August 9, 2016

Planning and Sustainability Commission
1900 SW 4th Avenue, #7100
Portland, OR 97201

Re: Proposed Zoning Code Changes in the 13th Avenue Historic District

Map 510-3

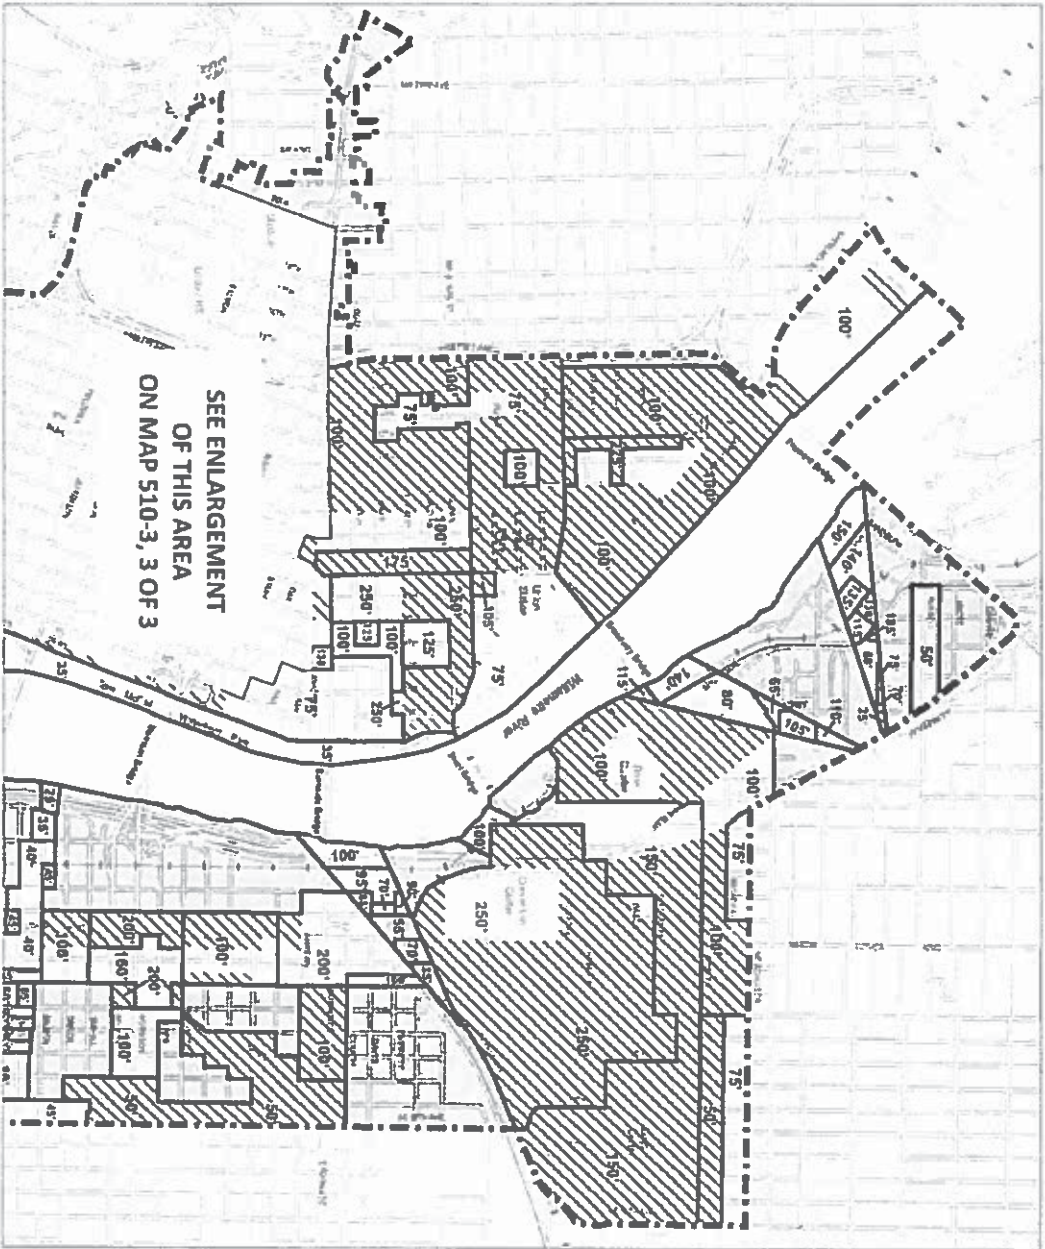
The proposed code revisions reduce the allowed base height from NW Davis Street to NW Hoyt Street from 100 feet to 75 feet and remove the District from any opportunity for even a limited height bonus, above this new lower base height. These changes are shown on Map 510-3, attached as Exhibit A and on the cross-section shown on the attached Exhibit B. Importantly, there are three contributing buildings in the District that already exceed 75 feet in height as shown on Exhibit C.

While the new height bonus provisions may exceed what is appropriate for the District, it is equally true that reducing the base height in the District from 100 feet to 75 feet between Hoyt and Davis, and taking away any reasonable option for a more appropriate and tailored height bonus, threatens the continued vitality of the District. For example, retaining the existing base heights and capping the FAR-related height bonus in the District at 45 feet through Landmarks Commission review will provide an avenue to add a few floors to an existing building and offer the necessary incentives to preserve and retain properties within the District. Retaining the FAR-related bonus will also support the City's affordable housing goals because, as discussed below, the first 2:1 FAR bonus earned in the District must now come from affordable housing or payment into the affordable housing fund. This FAR bonus will then be converted into a limited and reasonable height bonus, supporting both preservation of historic resources and affordable housing objectives.

1. *We support eliminating the potential 75-foot height bonus in current code for the District;*
2. *We support the allowed density transfers from contributing properties to pre-fund mandatory seismic upgrades through phased seismic upgrade requirements;*
3. *Retain an FAR or transfer related 45-foot height bonus for the 13th Avenue District;*
4. *Eliminate prioritization of density transfer from Skidmore/Old Town and new Chinatown/Japantown historic districts; and*
5. *Retain the 100-foot height base height limit from NW Davis Street to NW Hoyt Street as there are two contributing buildings in this portion of the district at approximately 80 feet and 88 feet in height respectively.*

Map 510-4

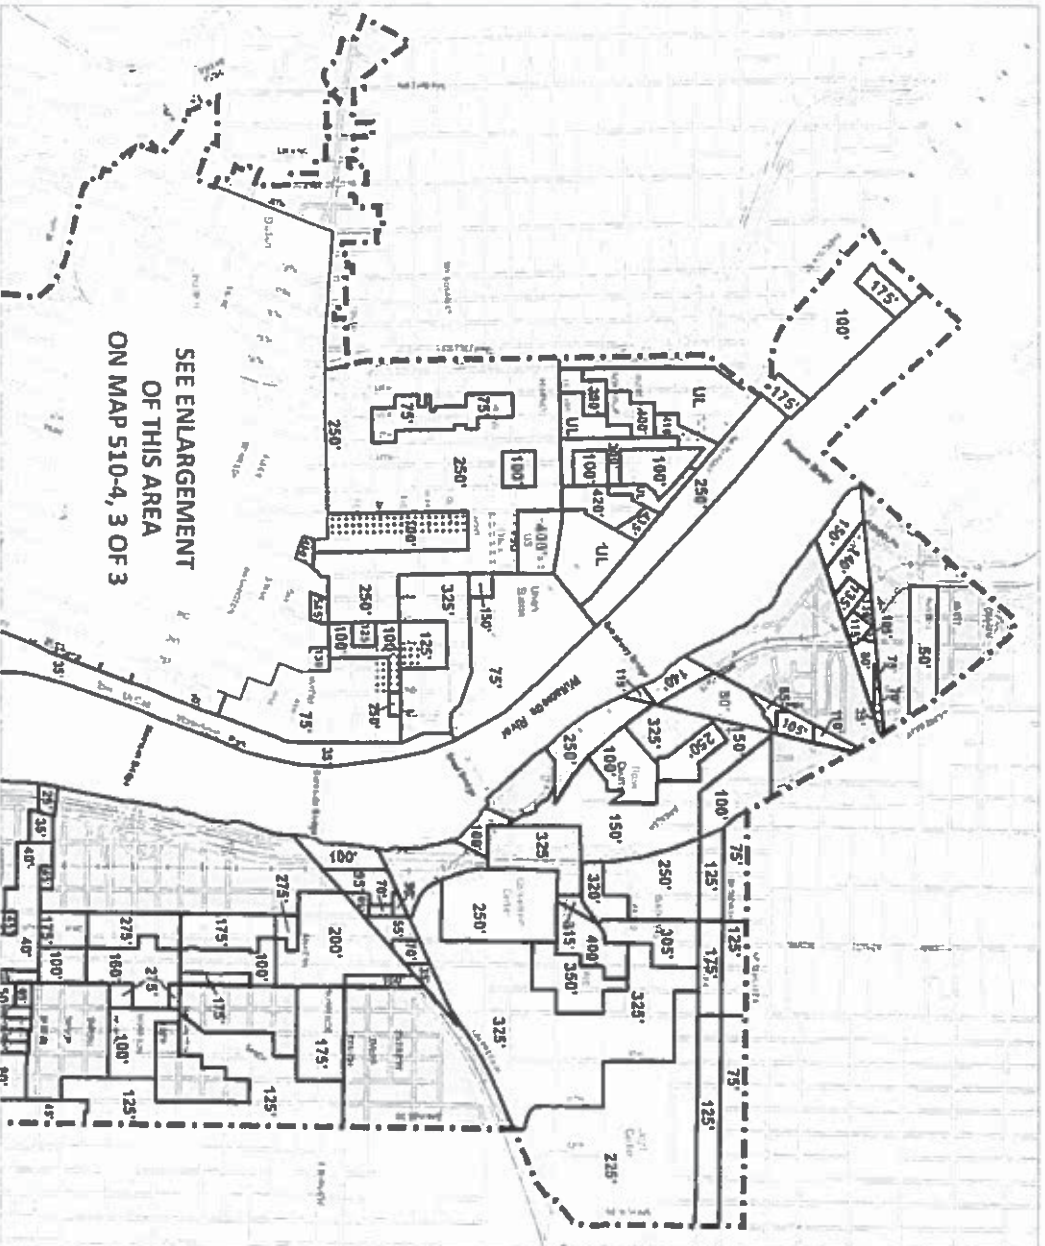
While our District suffers reduced base heights and no height bonus allowance, other properties still enjoy some level of height bonus. Under the proposed code, if a property outside of the District earns at least 1:1 FAR through the affordable housing bonuses or the historic FAR transfer provisions, the property can earn at least 75 feet in bonus height up to the new maximums on Map 510-4, attached as Exhibit D. For the 13th Avenue District, this means that properties in the District no longer have the opportunity to even put one or two floors on a 75 foot building through any review or height bonus but properties immediately adjacent to the District can reach heights of 250 feet.

HISTORIC DISTRICTS

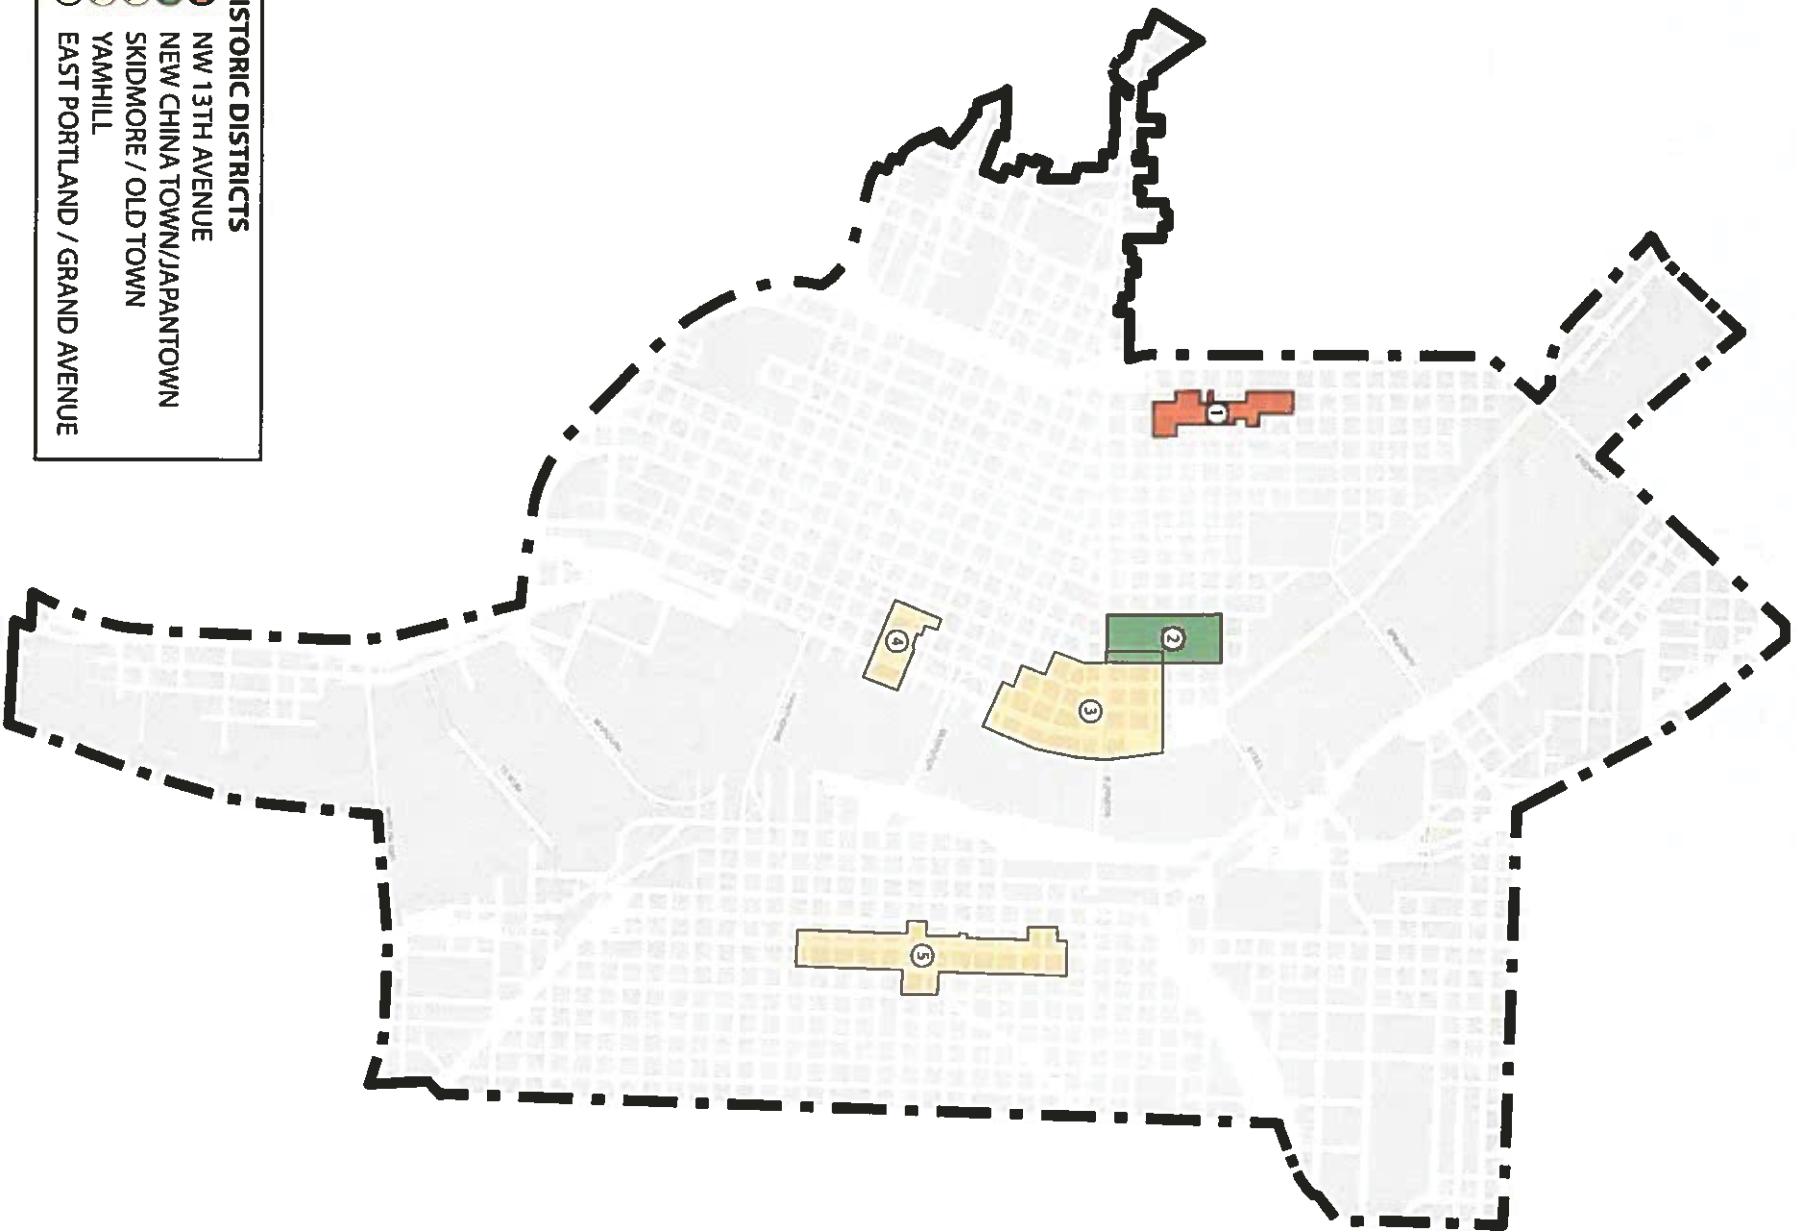
1. This provision values two historic districts and their resources over every other district or resource in the City (see Exhibit E). The only explanation for this priority is that the

two districts were identified as “key preservation priority areas” in the West Quadrant process. Were other districts studied using the same form of analysis or level of advocacy and found to be so much less important that they are secondary priority in the codified FAR transfer structure? There does not appear to be a sound basis or adequate record for creating such a priority amongst historic resources in the City; and

2. This priority significantly devalues the 13th Avenue historic FAR because it cannot be used until someone proves that there is no available FAR in the two identified districts to transfer. The system puts a premium on the FAR rights from Old Town and Japantown and devalues the “secondary” or “inferior” FAR from 13th Avenue. The 13th Avenue District is not inferior or secondary and the code should not aim to make it so.

The value of this new transfer allowance is also not a given and is instead dependent on whether there is any market for the historic FAR after the primary market from Old Town and Japantown is absorbed. Thus, the increased transfer potential should not be viewed as a mitigating factor for reducing the base height and taking away any height bonus in the District. Instead the base and appropriate bonus height should be preserved and the transfer provisions should be adopted with equal priority for all Historic Districts.
